# Technical Memorandum

**Subject** 78-90 Beechwood Avenue/ 69-93 Barrette Street - TIA Addendum 1

This technical memorandum has been submitted in response to City's transportation-related comments received on November 19, 2020, regarding the Transportation Impact Assessment (TIA) – Step 4 report for 78-90 Beechwood/ 69-93 Barrette, dated July 30, 2020. The TIA was prepared in support of both a Zoning By-Law Amendment Application as well as Site Plan Control.

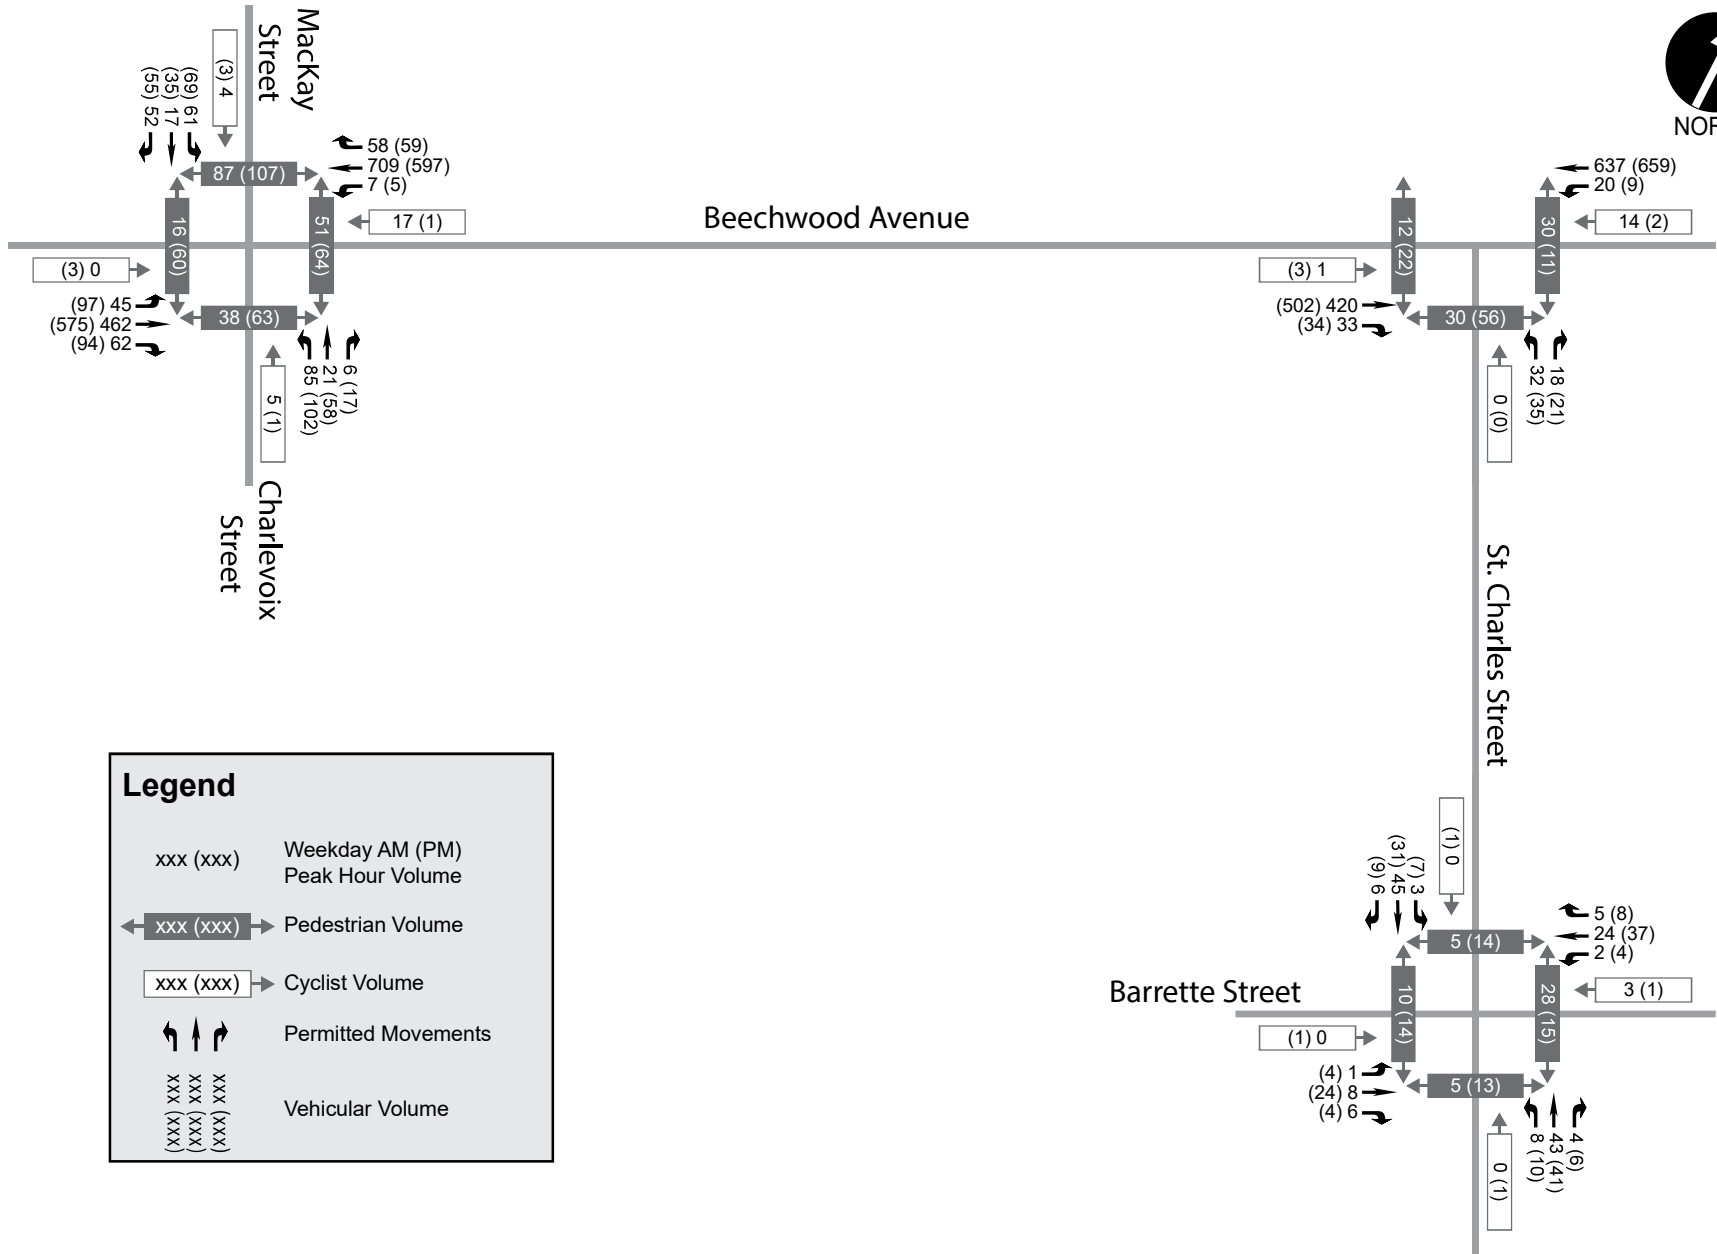
Concern that:

- Then when presenting the result of the traffic impact of the proposed development between 2023 and 2028 (TIA – Exhibits 7 & 8 – pages 31-32), one can easily calculate that, in 2028, the (41) extra vehicle predicted during PM peak hours going Eastbound on Beechwood and entering the intersection with Mackay and Charlevoix represents in fact a 5% increase of the (786) background vehicular traffic of 2023 at the same location.

This short section of Beechwood, between the Vanier Parkway/Crichton street and Charlevoix/Mackay streets is arguably the busiest part of Beechwood Avenue. So my question to the developer is the following: since the traffic in the busiest section of Beechwood can be increased by 5%, just by one new development in the area, do you think that the assumption of no traffic growth between 2011 and 2031 is reasonable? And if it is not reasonable as anyone would realize from your own study, why did you accept this assumption? Just because it is provided by the city?

➤ **IBI Response: It is acknowledged that, generally, all new development *does* generate additional vehicular traffic, however it is minimized by Transportation Demand Management measures in accordance with City policy. As described previously, this is offset by a reduction in background traffic as a result of the City's investment in transit and active transportation infrastructure as well as individual TDM measures of adjacent developments. In essence, new traffic generation is minimized while a portion of existing traffic shifts to more sustainable modes.**

Streetscape Improvements - Interim Configuration

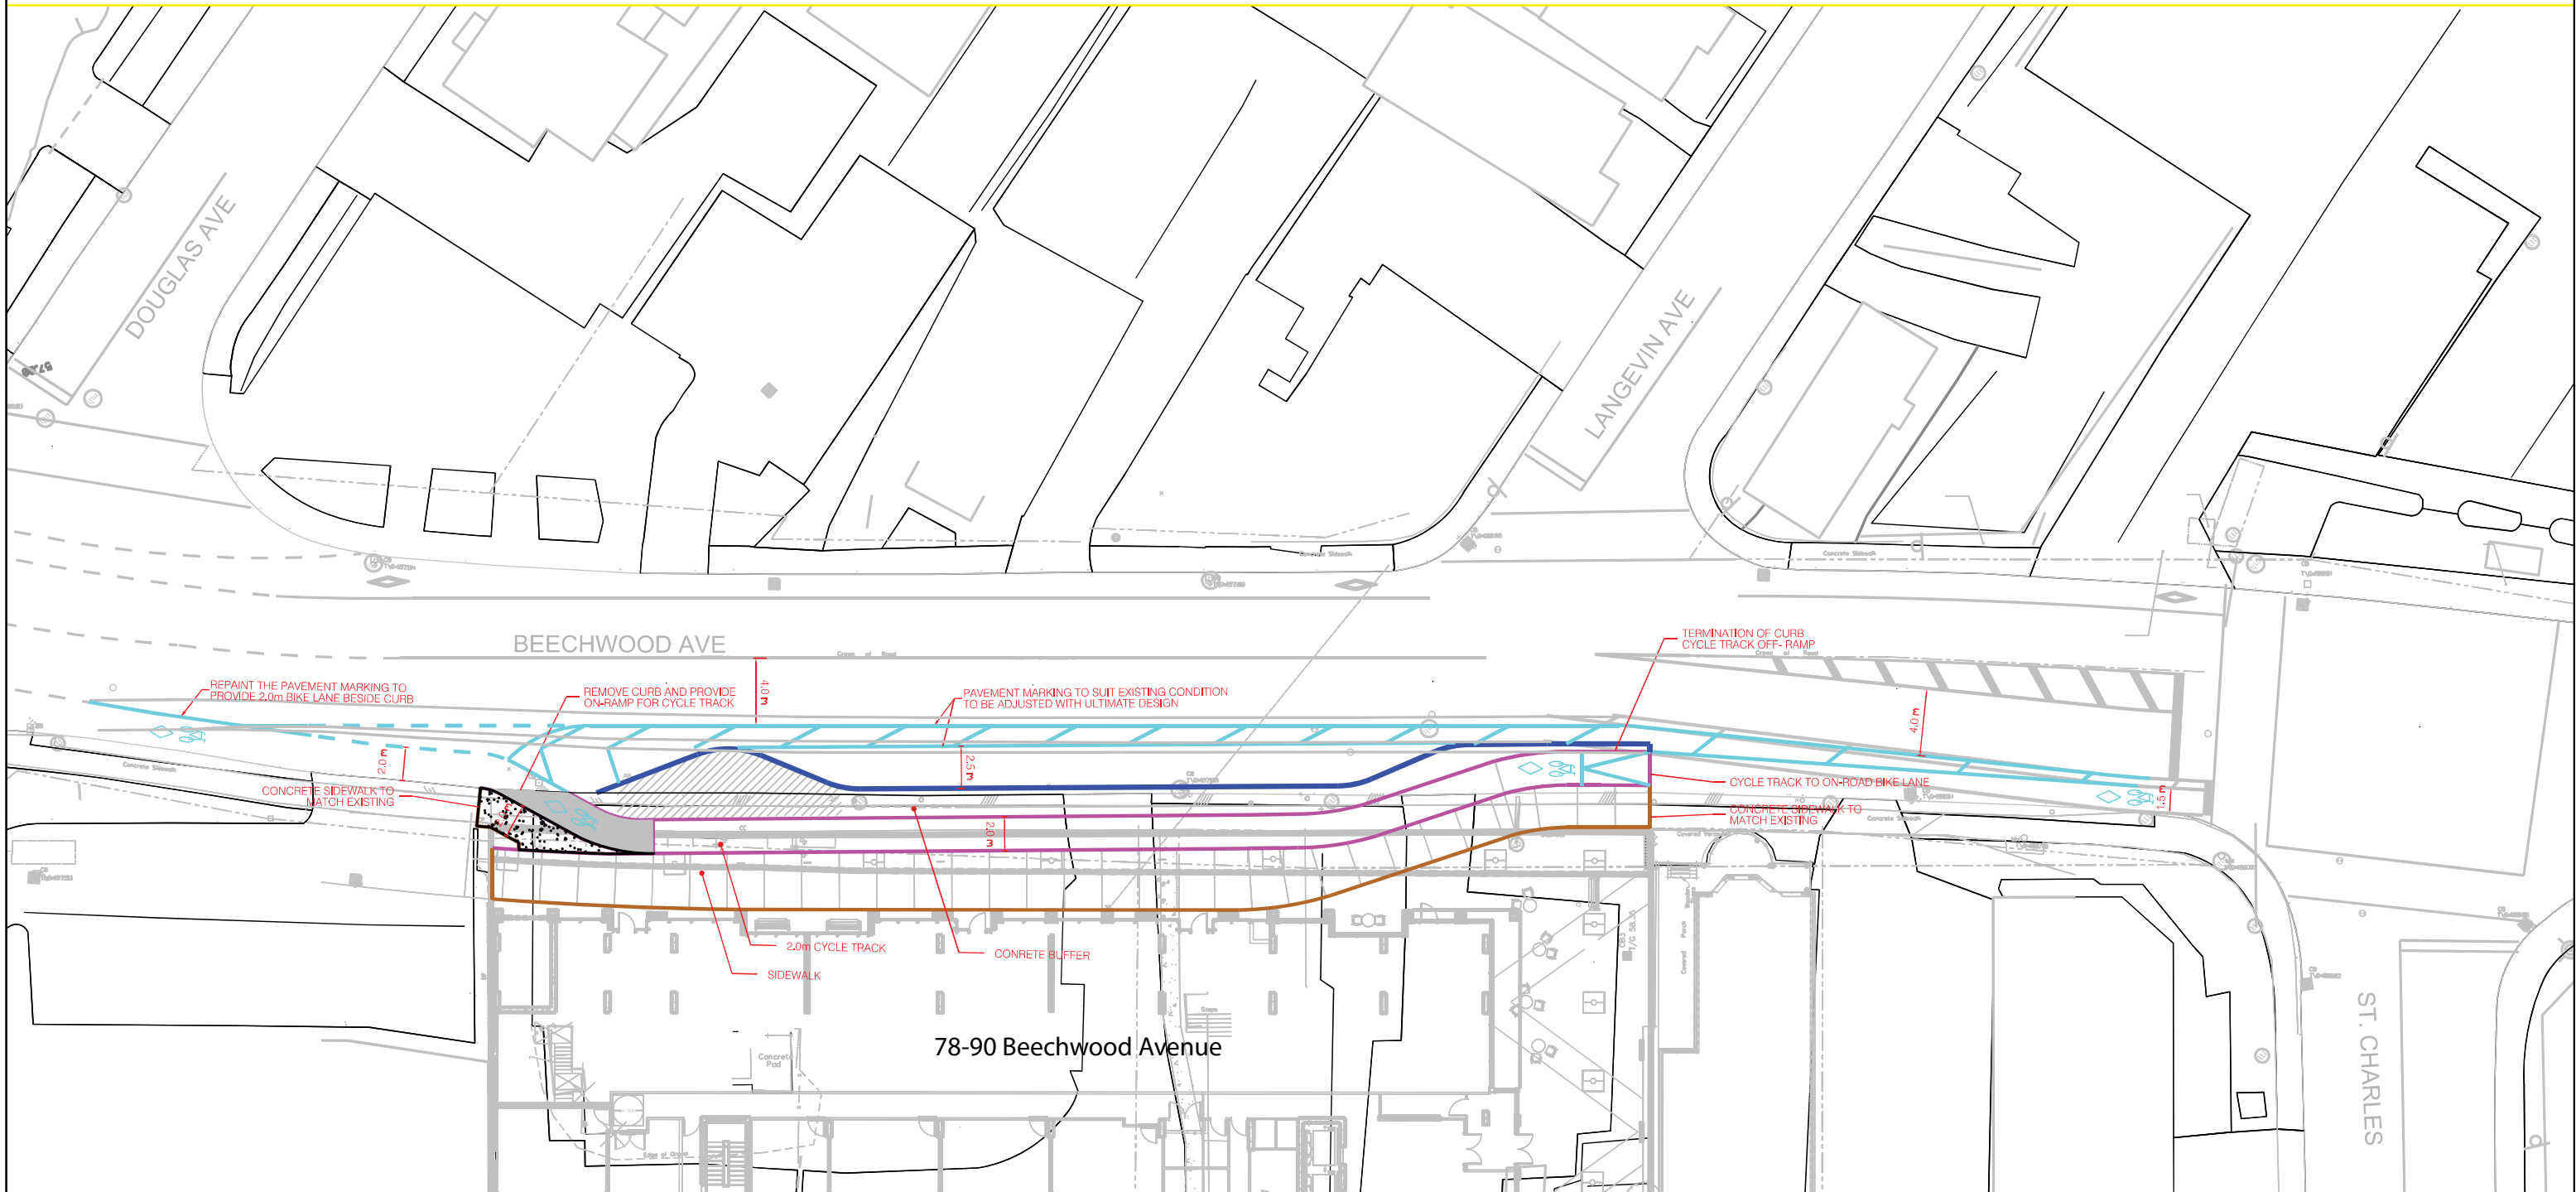
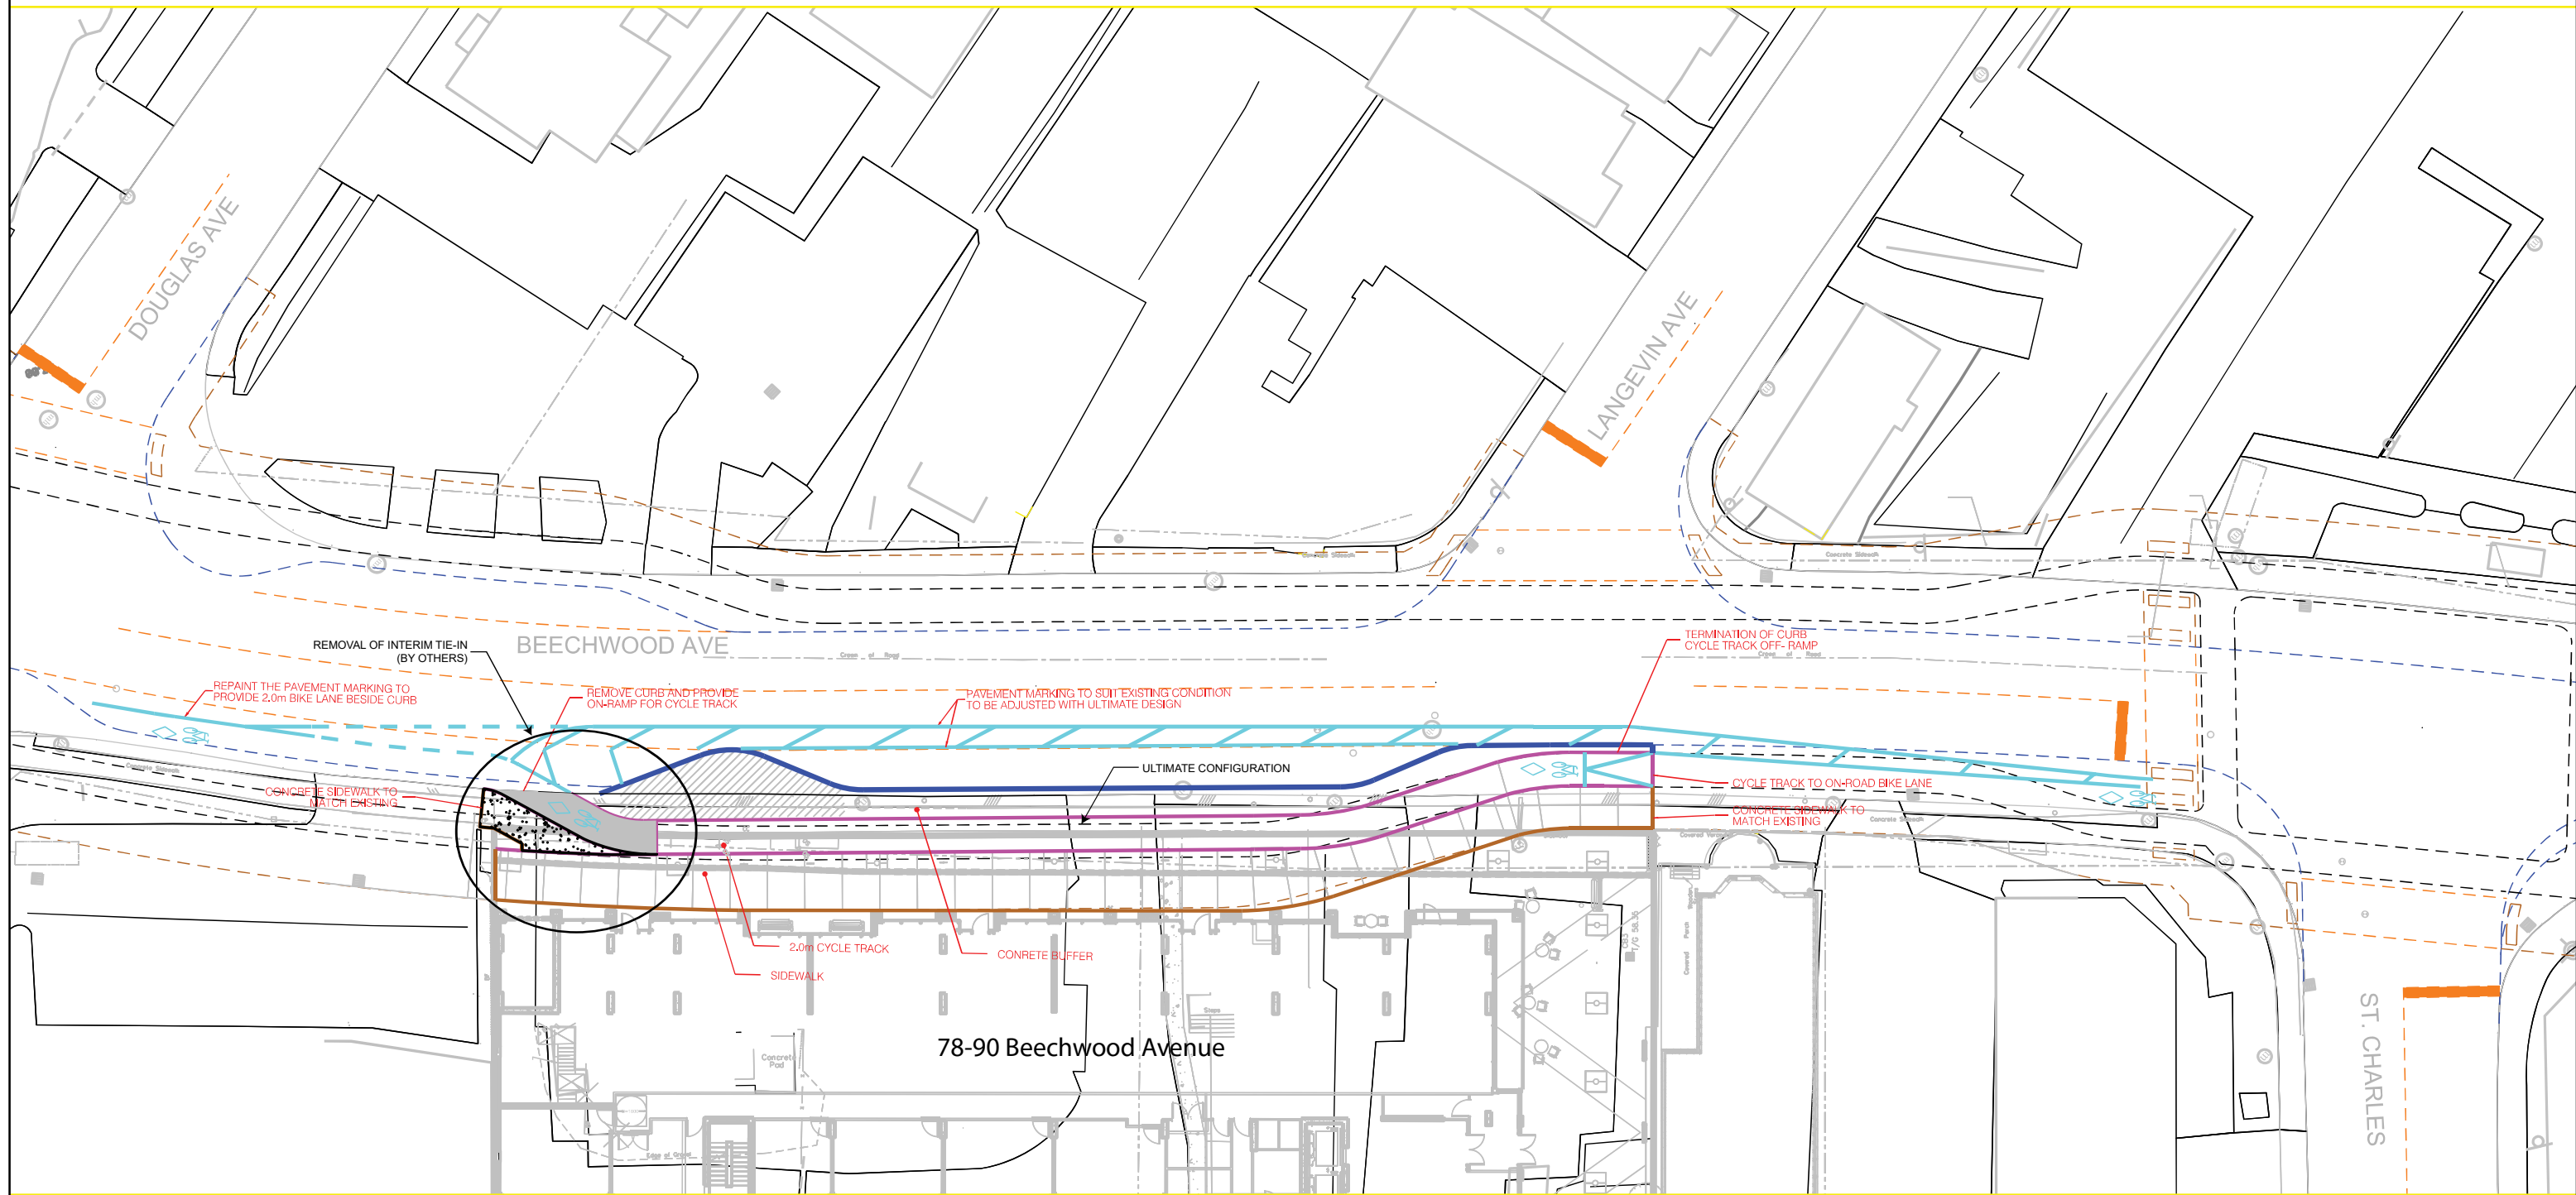
- a) A functional design of all proposed road modifications is required as part of the submission of the site plan application. Coordination with neighbouring road modifications may also be required. There may be delays in the application given the incomplete submission.
  - **IBI Response: Acknowledged. As part of the TIA process, a functional design was undertaken in coordination with City staff to accommodate an eastbound cycle track and a wider sidewalk in the along the site's Beechwood Avenue frontage. The design drawings have taken into consideration the under-construction cycle track design for the segment of Beechwood Avenue east of St. Charles Street as well as the ultimate corridor plan. Drawings illustrating the interim tie-in to existing conditions as well as the coordination with planned conditions are included in Appendix C.**
